PRELIMINARY GEOLOGY, SURFACE SOILS, AND SEWAGE DISPOSAL EVALUATION  
**WALDEN PRESERVE SUBDIVISION**  
EL PASO COUNTY, CO

AMENDED June 25, 2022

- REVISED FIG 2 – PRELIMINARY GEOLOGIC MAP
- REVISED FIG 3 – SEWAGE DISPOSAL CHARACTERISTICS MAP
- LETTER REQUEST TO PCD DIRECTOR

Re: Walden Preserve Subdivision 2, Fil 5 Final Plat Application – SF2211

FIGURE "2" PRELIMINARY GEOLOGIC MAP  
PRELIMINARY GEOLOGY, SURFACE SOILS, AND SEWAGE DISPOSAL EVALUATION  
FRONT RANGE GEOTECHNICAL, INC  
AUG 29, 2004

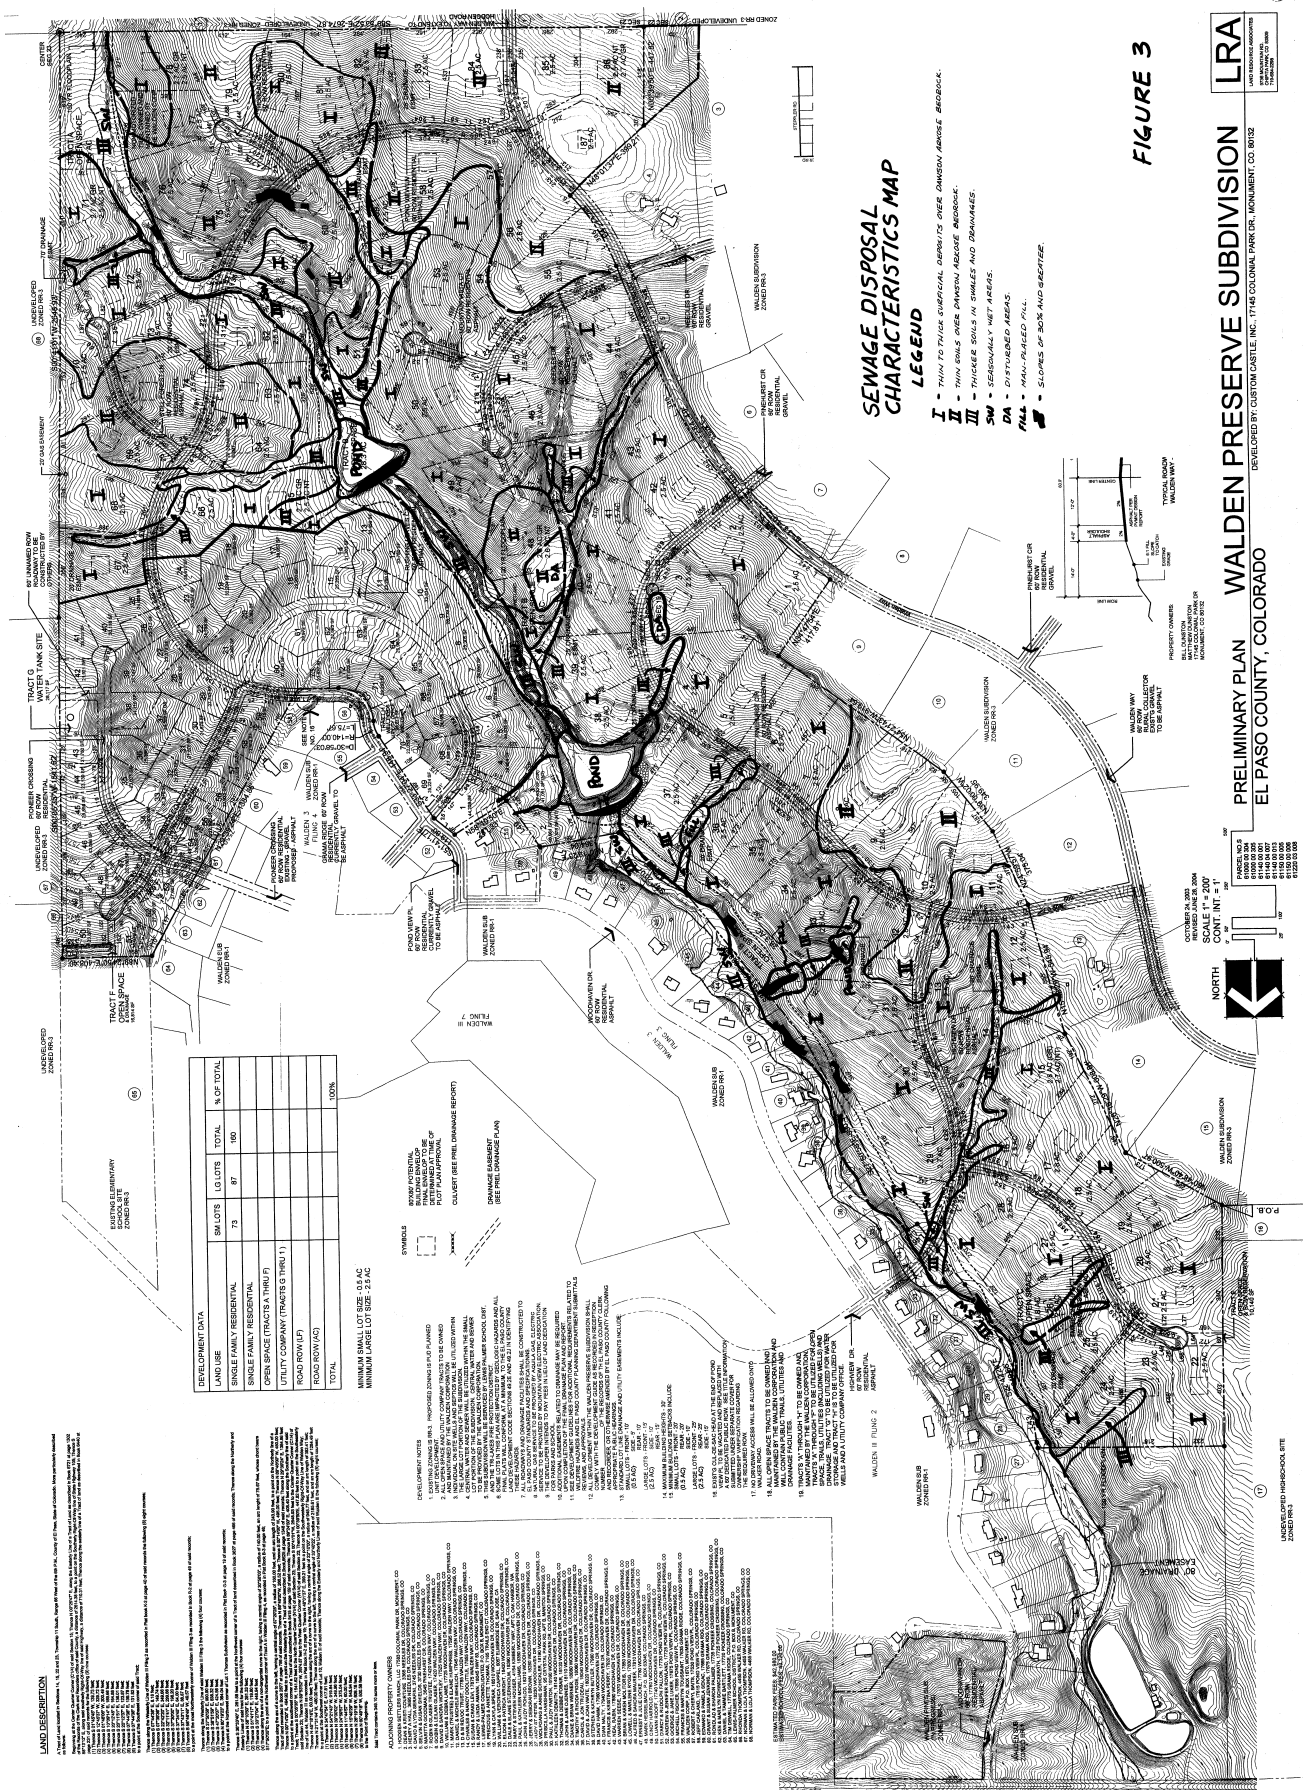
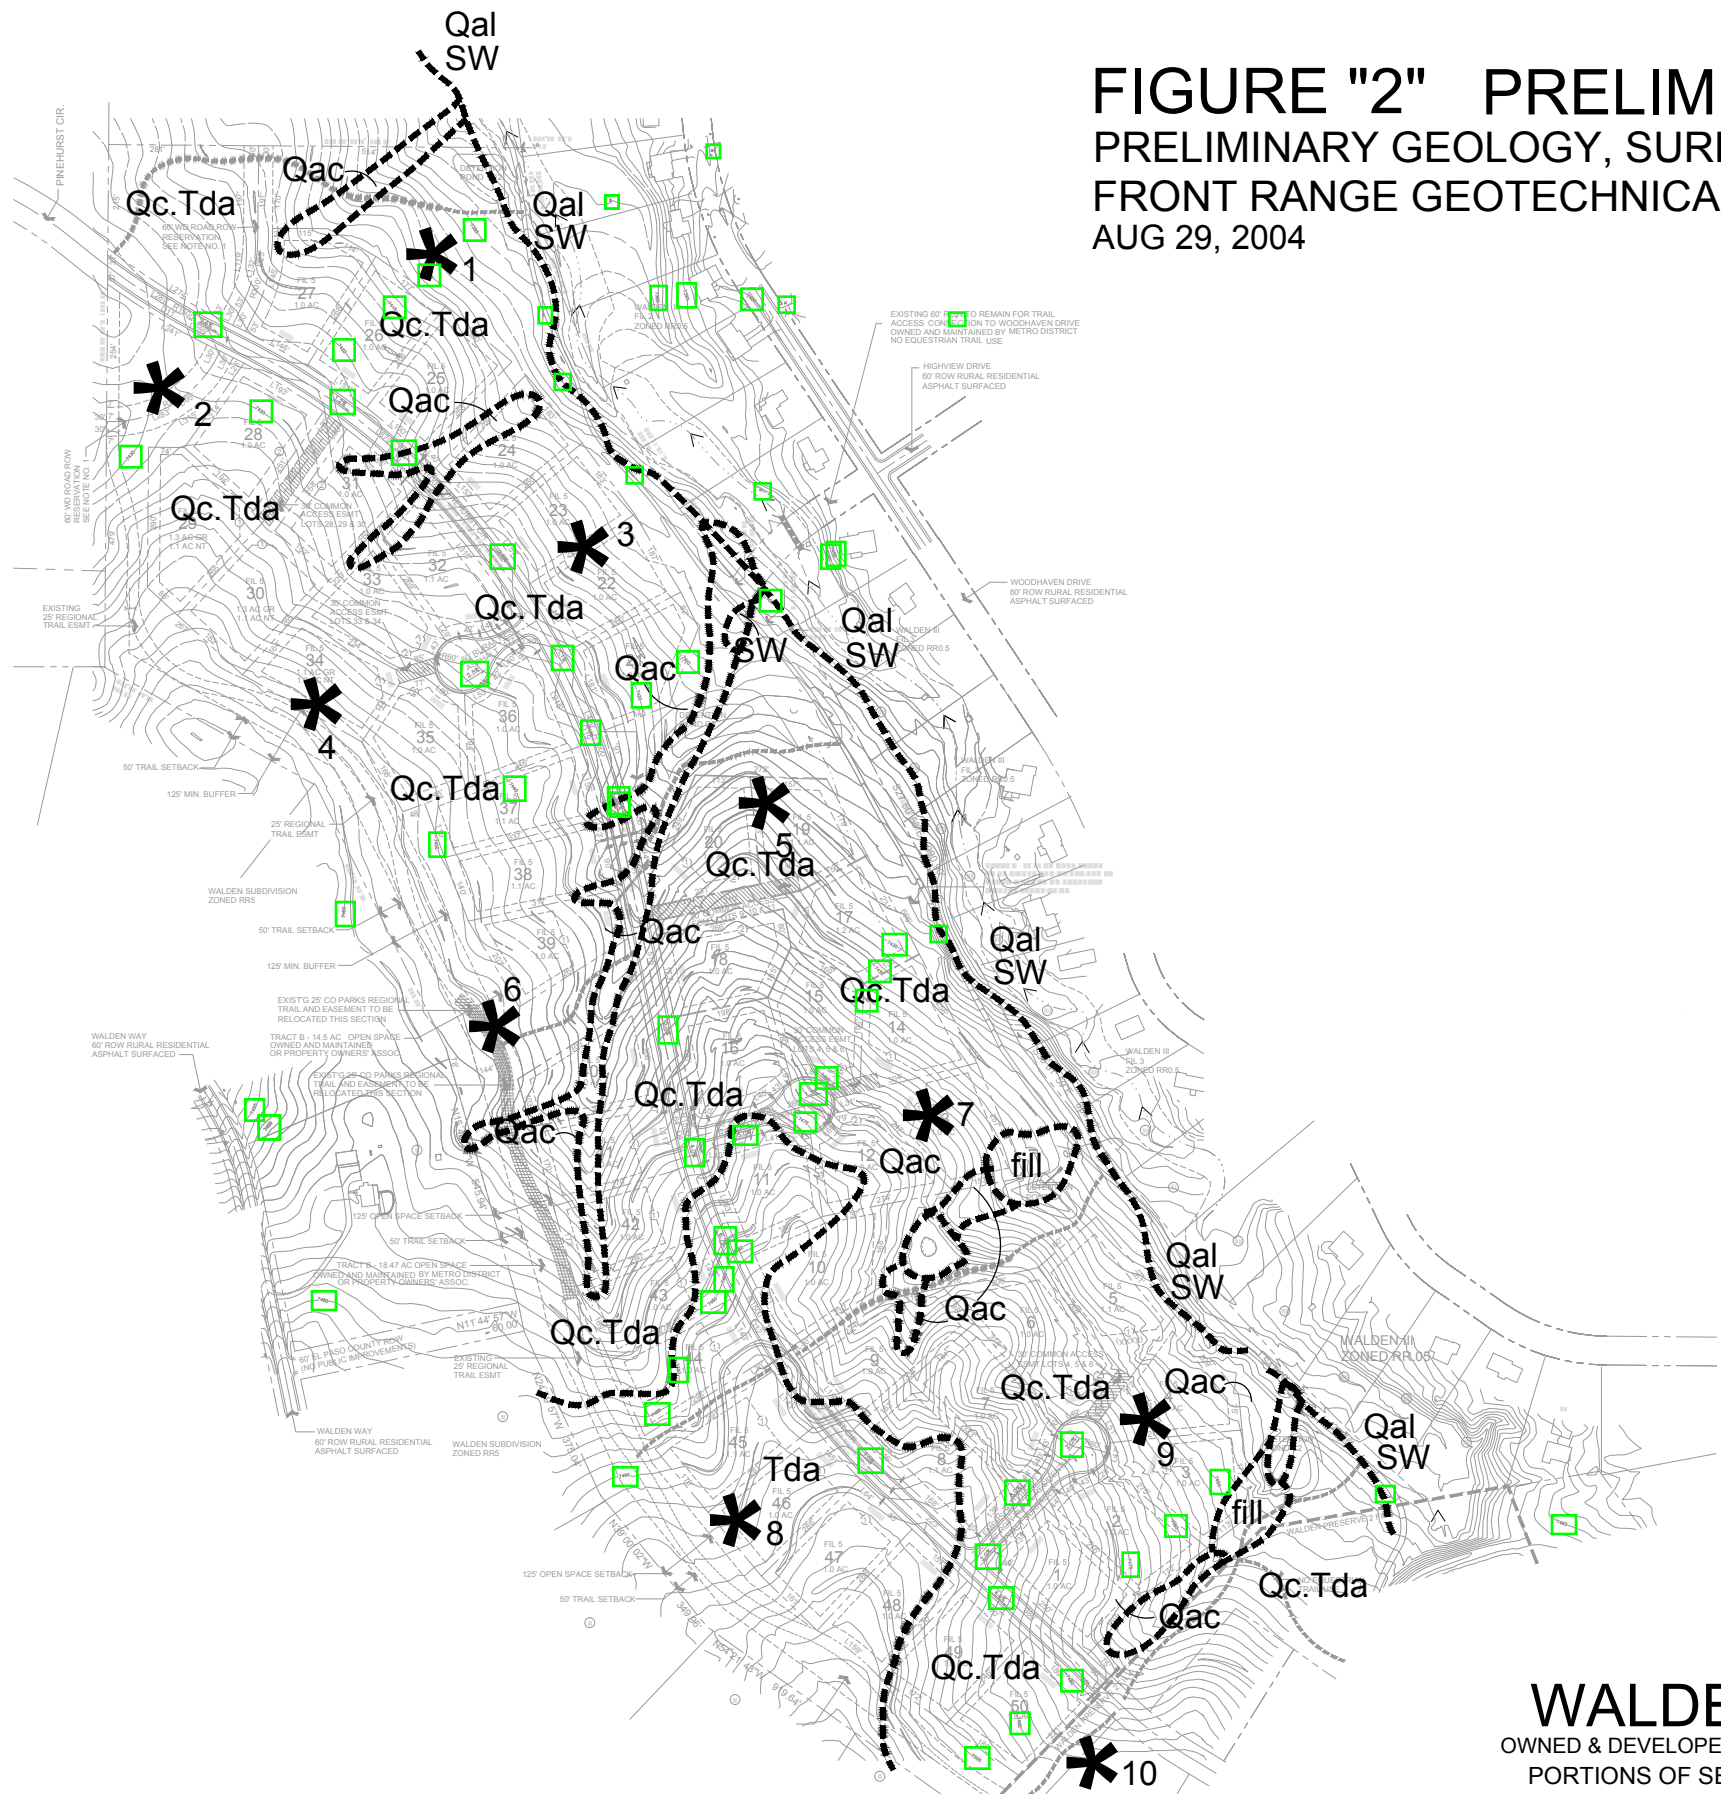
- Figures 2 & 3 within the report have been updated to reflect Front Range Geotechnical’s identified constraints on the current lot and roadway layout.
- No geologic hazards or constraints have been identified within Filing 5’s lots or roadways.
- The subdivision will be served by both central water and sewer eliminating geologic concerns and constraints related to onsite septic systems.
- The report has been utilized in obtaining numerous land use approvals including; Preliminary Plan, PUD Development Plan and Final Plat approvals for Filings 1 through 4.
- The Filing 5 Final Plat approval is the last of the Walden Preserve 2 development applications.
